Bulletin 1

Reference No.: Invitation to Bid - UNDP/ITB/05/2015

Purpose: Supply and Delivery of Prefabricated Office Blocks

Question and Answers

Foundation detail for pole

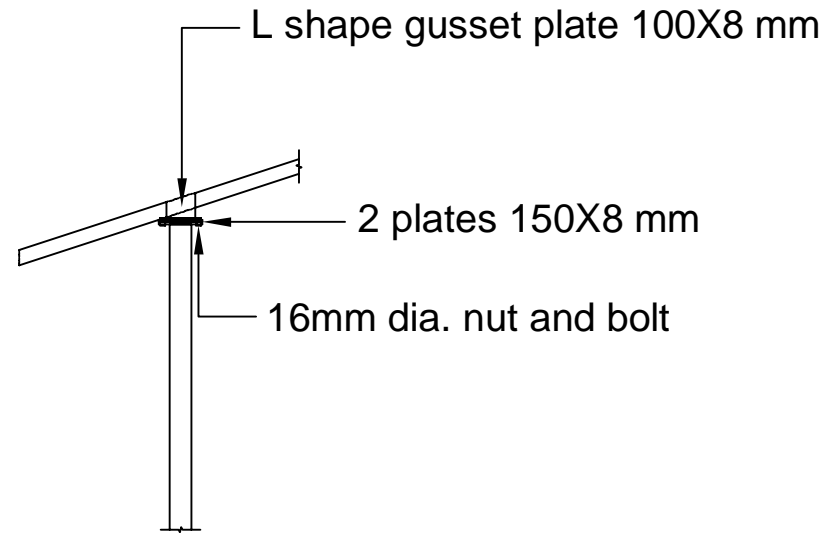
1. The cross section of drawing (Block) is not provided which makes the height of masonry wall, 3"/2" MS pole of heavy duty unclear. Dimension of foundation is not provided. The design drawing is incomplete which may cause problem while construction

Answer: The design/drawing of the truss is now attached and the measurement of the Truss is as follows:

- Height of masonry wall – 2'
- Height of 3" MS Pole of heavy duty – 14'
- Height of 2" MS Pole of heavy duty – 12.5'
- The respective span (width) of Type A and Type B buildings: 45 feet and 40 feet
- Dimension of foundation: Details provided in the design
- Other details are found from the enclosed design.
